UN Regulation No. 137 (Frontal impact with focus on restraint systems)

Proposal for the 04 Series of Amendments to UN Regulation No. 137 (Frontal collision with focus on restraint systems)

Submitted by the expert from Japan^{*,}**

Model A

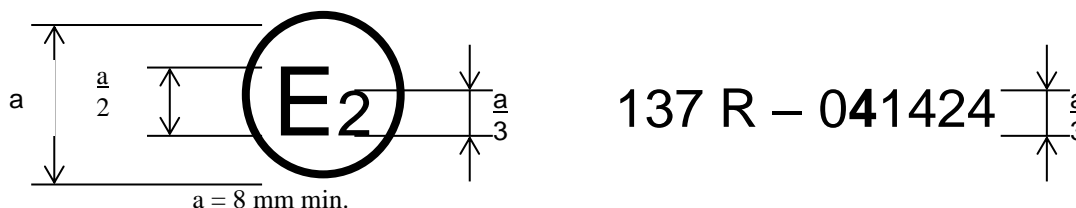
Annex 2, amend to read:

The above approval mark affixed to a vehicle shows that the vehicle type concerned has, with regard to the protection of the occupants in the event of a frontal collision, been approved in France (E 2) pursuant to Regulation No. 137 under approval number 0341424. The approval number indicates that the approval was granted in accordance with the requirements of Regulation No. 137 034 series of amendments.

Model B

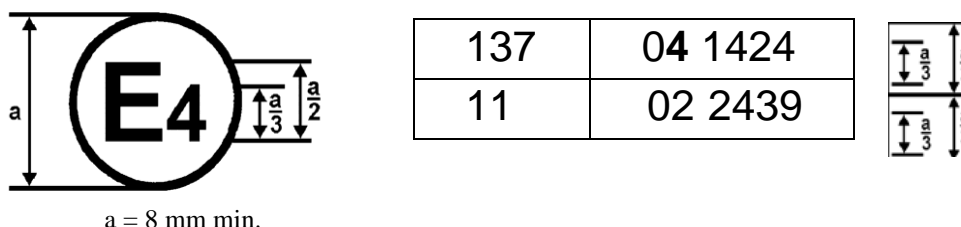
The above approval mark affixed to a vehicle shows that the vehicle type concerned has been approved in the Netherlands (E 4) pursuant to Regulations Nos. 137 and 11.¹ The first two digits of the approval numbers indicate that, at the dates when the respective approvals were granted, Regulation No. 137 incorporated the 034 series of amendments and Regulation No. 11 incorporated the 02 series of amendments."
